BULLETIN NO. 1088
ISSUE 2
JANUARY, 1944

TYPING REPERFORATOR

MODEL 14

TELETYPE
CORPORATION
SUBSIDIARY OF
Western Electric Company
CHICAGO, U.S.A.

98876 RIBBON FEED ASSEMBLY-RIGHT

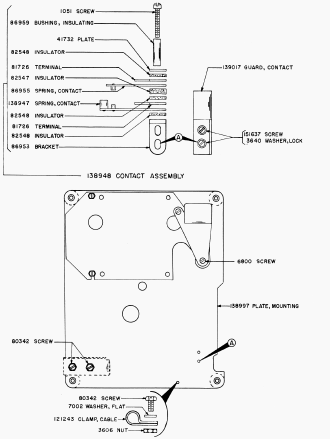
THIS CORRECTION SHEET COVERS PARTS ORDERING INFORMATION FOR THE FOLLOWING UNITS WHICH WERE NOT COVERED IN THE BULLETINS LISTED ABOVE

136101 MODIFICATION KIT TO PROVIDE REMOTE CONTROL BACKSPACE

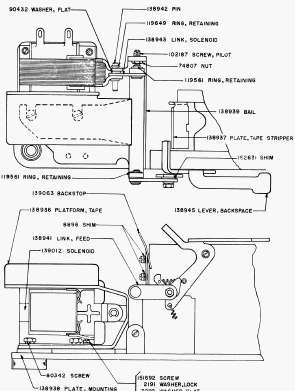
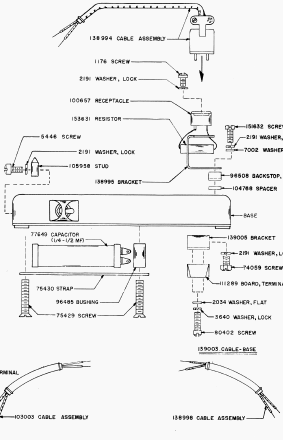
138994 CABLE ASSEMBLY
1176 SCREW
2191 WASHER, LOCK
100667 RECEPTACLE
138831 RESISTOR
154832 SCREW
2191 WASHER,LOCK
7002 WASHER,FLAT
5446 SCREW
2191 WASHER, LOCK
105958 STUD
138995 BRACKET
96808 BACKSTOP, COVER
104788 SPACER
BASE
77649 CAPACITOR
(1/4-1/2 MF)
139008 BRACKET
2191 WASHER,LOCK
74059 SCREW
111289 BOARD,TERMINAL
75430 STRAP
96485 BUSHING
75429 SCREW
2034 WASHER,FLAT
3640 WASHER,LOCK
80402 SCREW
159003 CABLE-BASE
82474 TERMINAL
103003 CABLE ASSEMBLY
138998 CABLE ASSEMBLY
